Draft Final Decision Document
for the North Boundary System
Improvements Interim Response Action
at the Rocky Mountain Arsenal

April 1989

COMMENTS ON THE PROPOSED DECISION DOCUMENT FOR THE
NORTH BOUNDARY SYSTEM IMPROVEMENTS INTERIM RESPONSE ACTION
JANUARY 1989

Figure 3. Generalized Alluvial Groundwater Flow Across RMA
(NOTE: Arrows are indicative of direction of flow and do not represent flow quantities.)

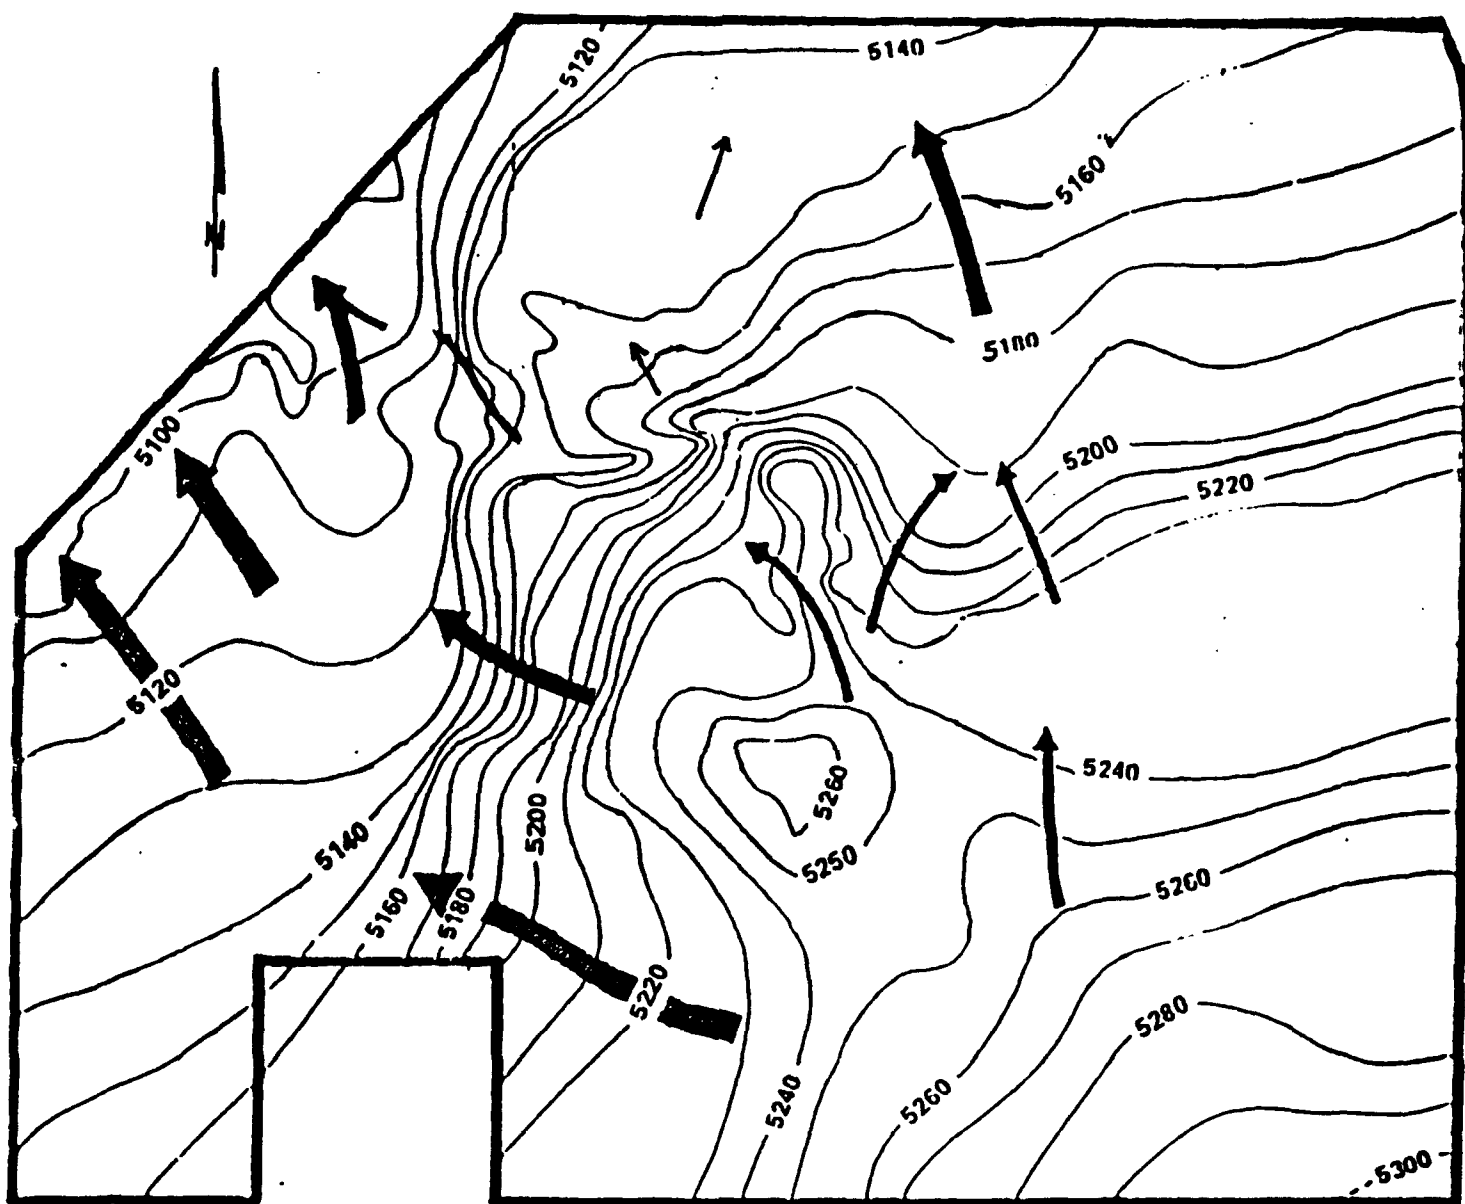
2. Page 5, Figure 3.

The arrows representing flow towards the northern Arsenal boundary incorrectly imply that the groundwater flow from the vicinity of Basin F is similar in magnitude to the groundwater from the vicinity of First Creek. The groundwater flow from the First Creek vicinity is much greater than the flow from the vicinity of Basin F. The arrow roughly in vicinity of Basin C and Basin F is also disproportionately large. In fact, recent hydrogeological investigations in this area provide evidence that this flow is almost nonexistent. Replacing this entire figure with a figure showing more up-to-date information is recommended.

RESPONSE: The arrows on Figure 3 have been reduced in size to de-emphasize the flows north of Basin F and from the vicinity of Basin C. The referenced source has been deleted. A note has been added to indicate that arrows are indicative of direction of flow and do not represent flow quantities.
